SUBJECT: RELOCATION OF HYDRAULIC CONTROL UNIT (HCU) ISOLATION BOUNDARIES,
LIMERICK GENERATING STATION, UNIT 2 (TSCR NO. 92-07-2)
(TAC NO. M84060)

Amendment No. 22
License No. NPF-85

SAFETY EVALUATION BY THE OFFICE OF NUCLEAR REACTOR REGULATION
RELATED AMENDMENT NO. 22 TO FACILITY OPERATING LICENSE NO. NPF-85
PHILADELPHIA ELECTRIC COMPANY
LIMERICK GENERATING STATION, UNIT 2
DOCKET NO. 50-353

FIGURE 1

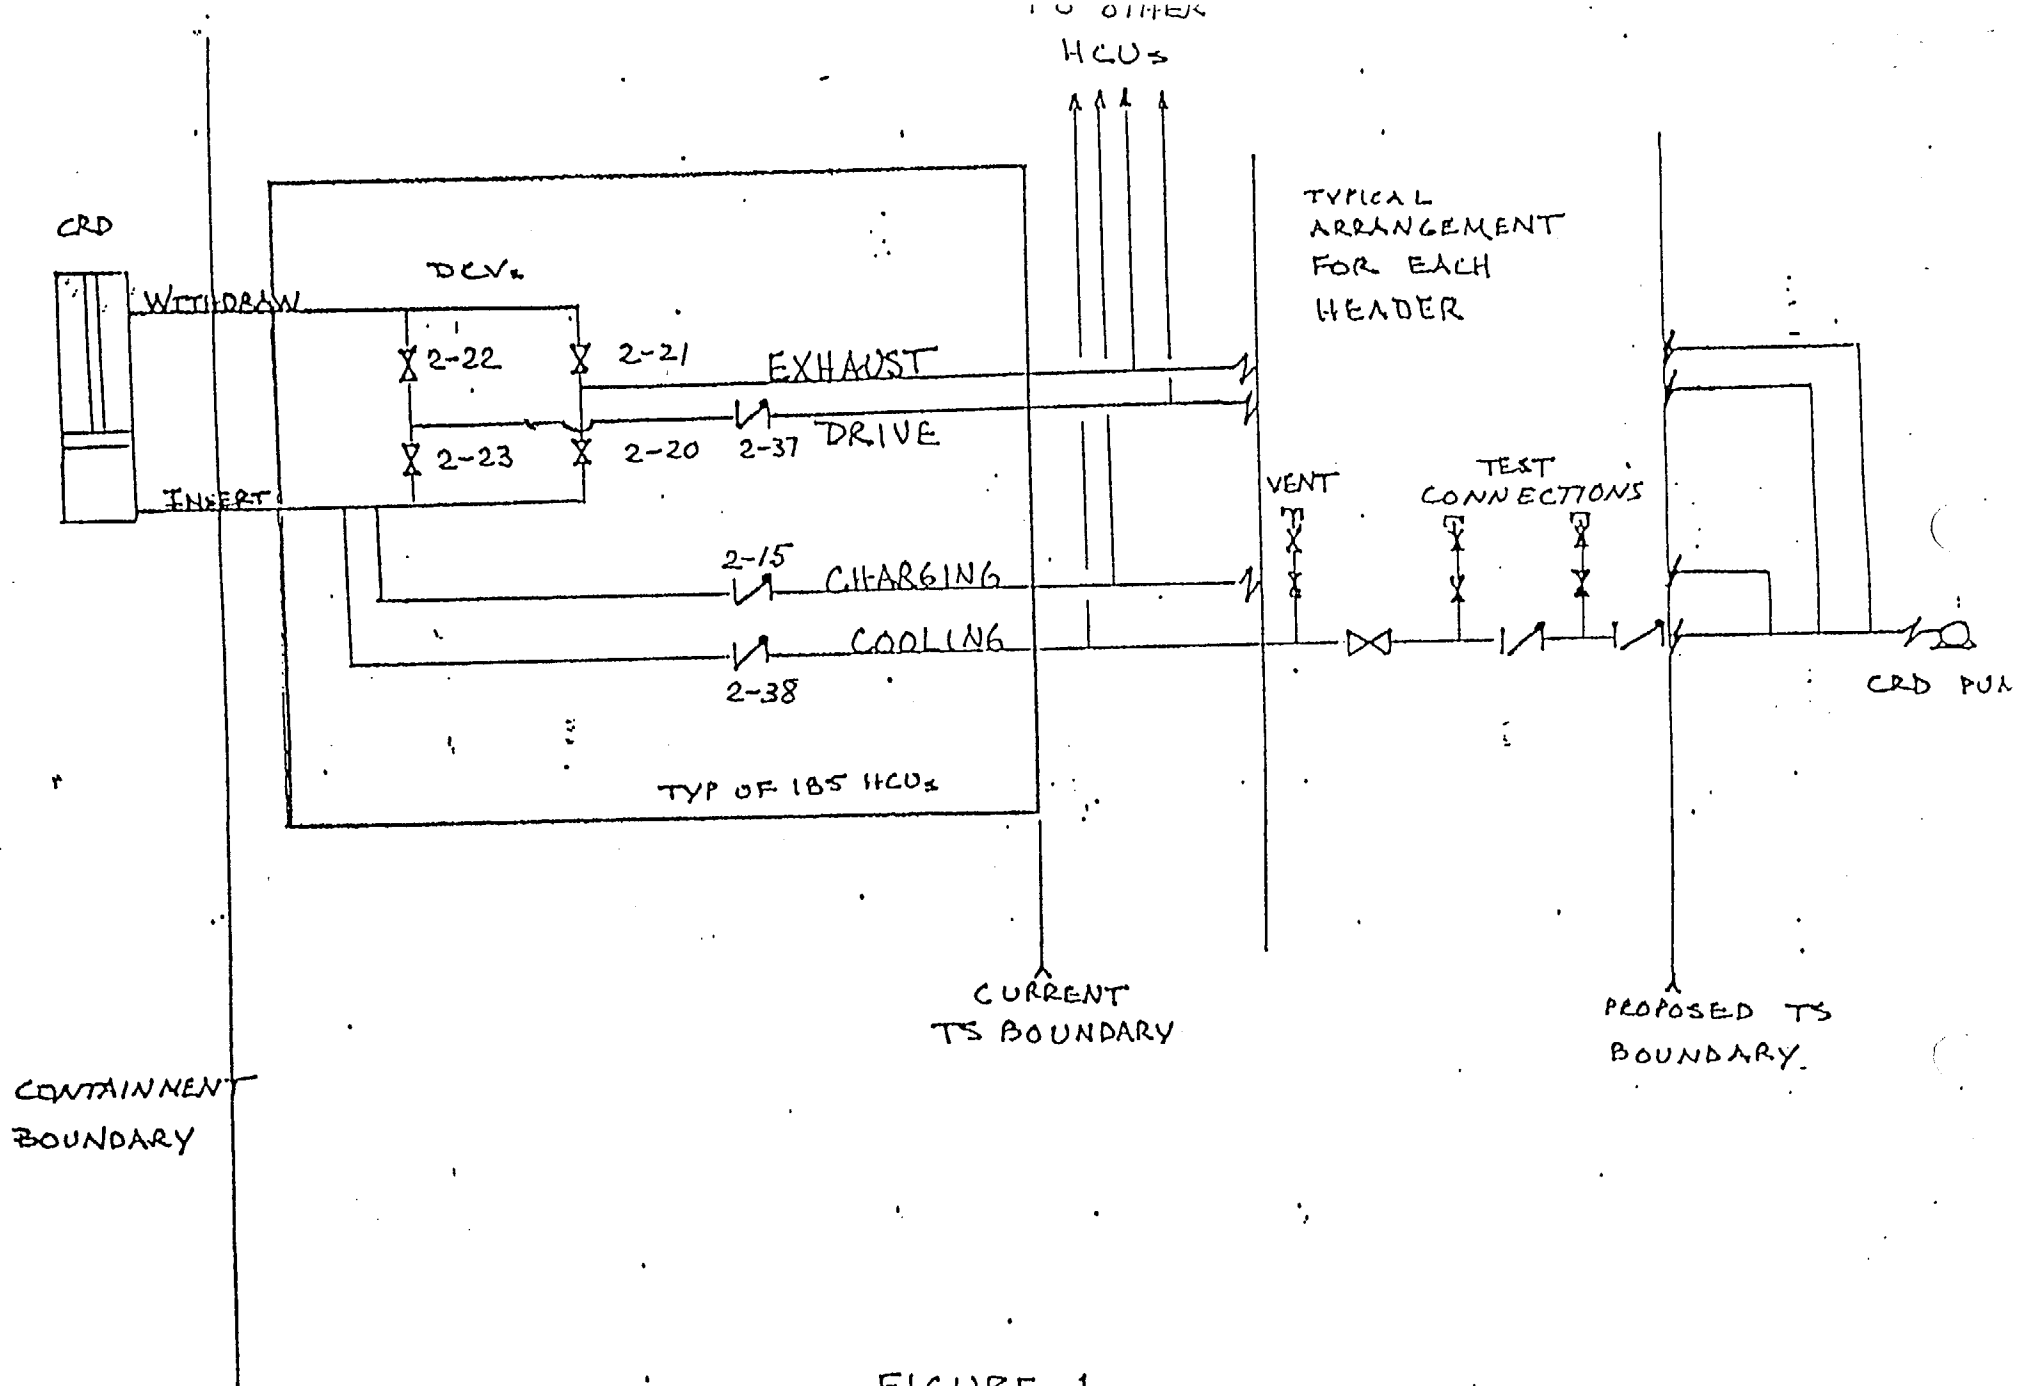
The licensee included a sketch of the proposed arrangement which is enclosed (Attachment 1). As shown, the licensee proposes to install two lift check valves, a manually controlled block valve and two test connections on each of the four CRD headers to the HCUs (drive, cooling, charging and exhaust). The general process diagram for the CRD hydraulic system is shown in figure 4.6.7 in the Limerick Updated Final Safety Analysis Report (UFSAR), which is also enclosed (Attachment 2). The new valves will be installed between the main control station and the existing vent valve shown in Attachment 1.

The proposed TS change will take credit for the new valves installed in each of the CRD headers to the HCUs (drive, cooling, charging, exhaust) between the main control station and the vent valve. These valves constitute a new isolation boundary. Each check valve station consists of two check valves, a block valve and two test connections. This enables each check valve to be tested individually instead of during the critical path ILRT. The change will move the isolation boundary out on the CRD headers. A new access platform has been installed in order to facilitate local testing of the added check valves. The new platform was designed to the American Institute of Steel Construction (AISC) and Category I requirements.

FIGURE 4.6-8

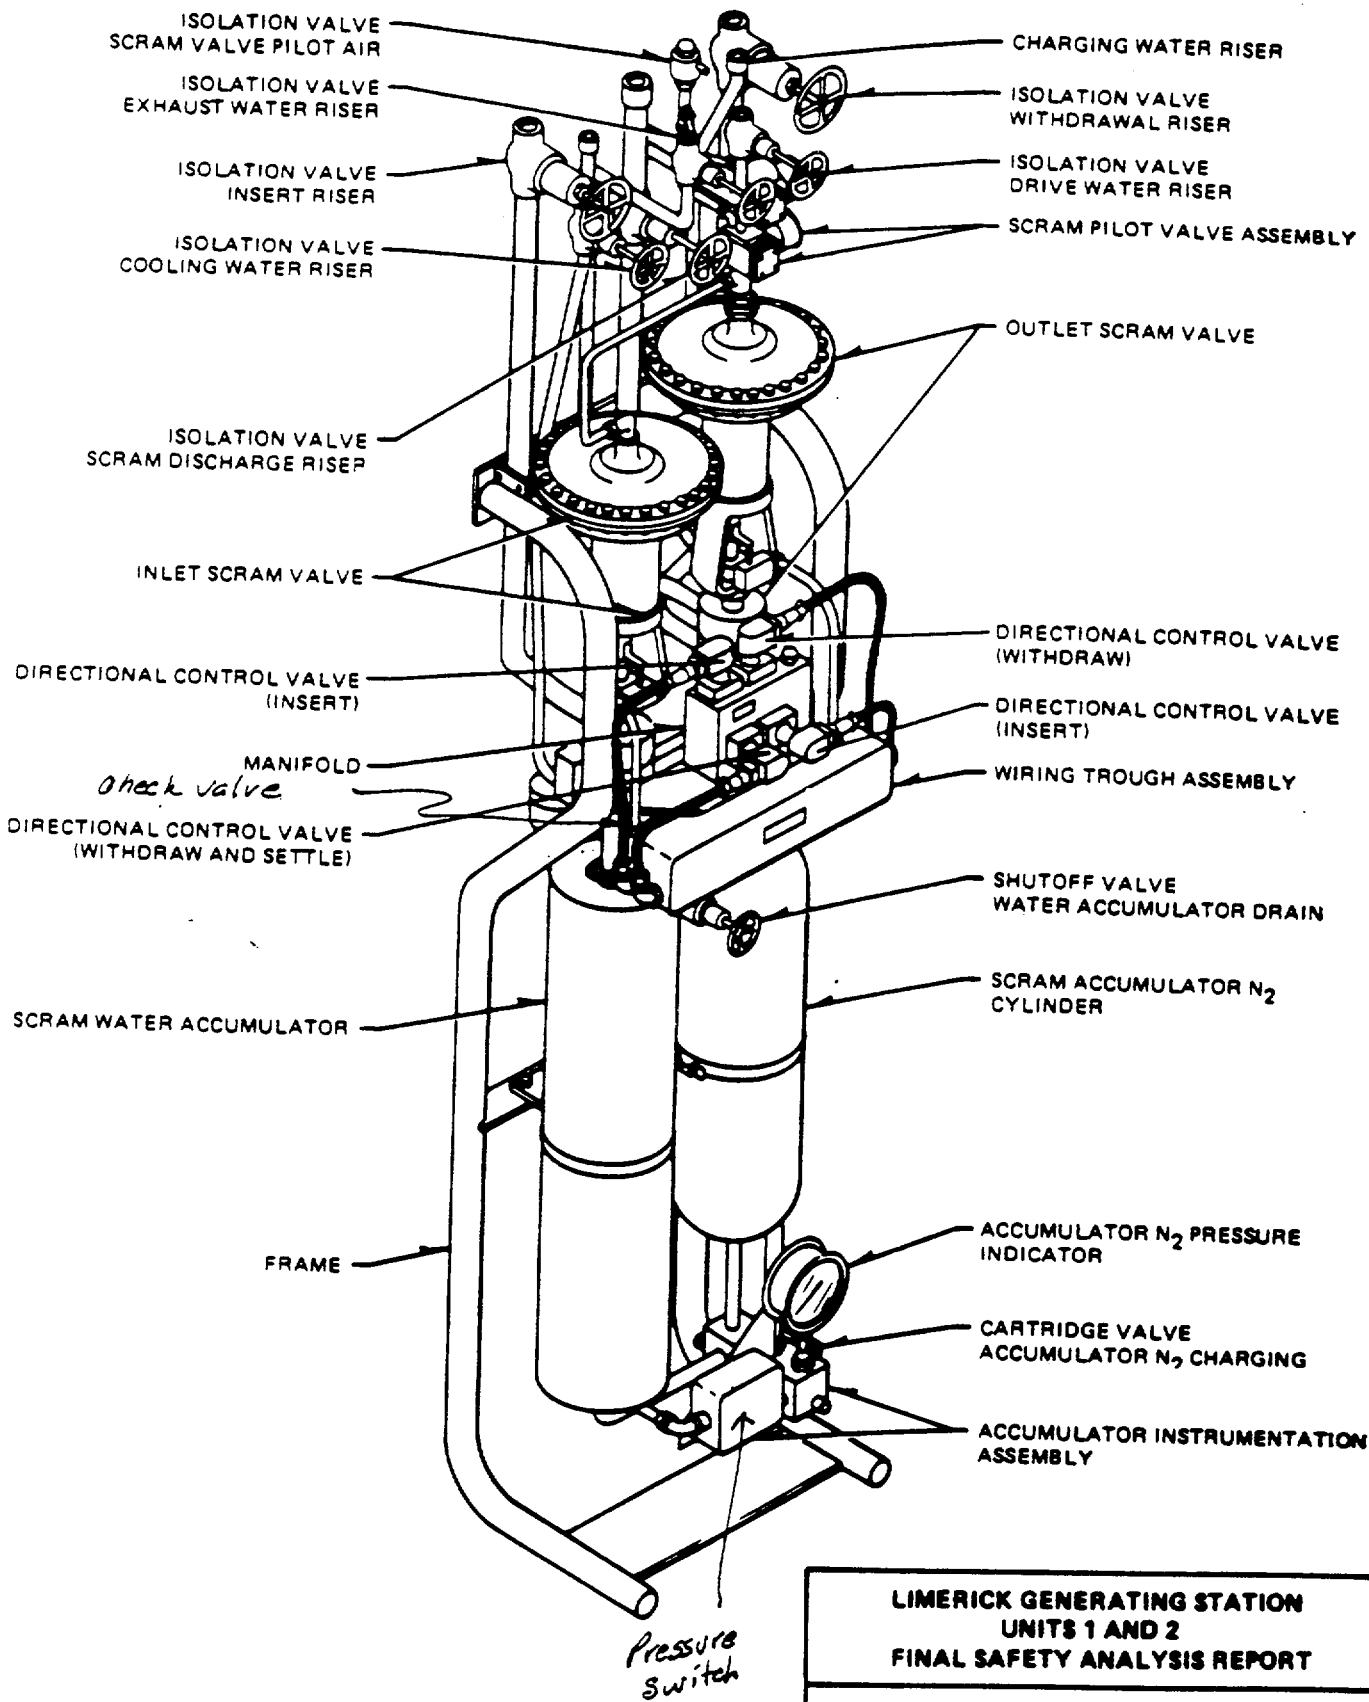
In a BWR 4 such as Limerick, Units 1 and 2, there are 185 control rods, each of which has an HCU. As shown on Figure 4.6.8 in the UFSAR (Attachment 3), and in Attachment 1, there are 3 check valves and 4 directional control valves on each HCU for a total of 1295 valves. The ILRT is a pressurization of primary containment and measurement of total leakage from all isolation boundaries. The current method of testing the isolation boundary of the CRD system is to place a bucket under the vent valves shown in Attachment 1 and to collect leakage through the HCUs at the vent valves on each of the four supply headers during an ILRT. If the total leakage exceeds specified limits, approximately 1300 individual check valves or solenoid valves must be examined to find and repair leak paths. Experience has shown that the total leakage is usually due to a drop or two of water leakage from many of the ball check valves rather than failure of one or two valves. To avoid these problems, the licensee proposes to relocate the isolation boundary on the headers to and from the HCUs rather than on the HCUs.
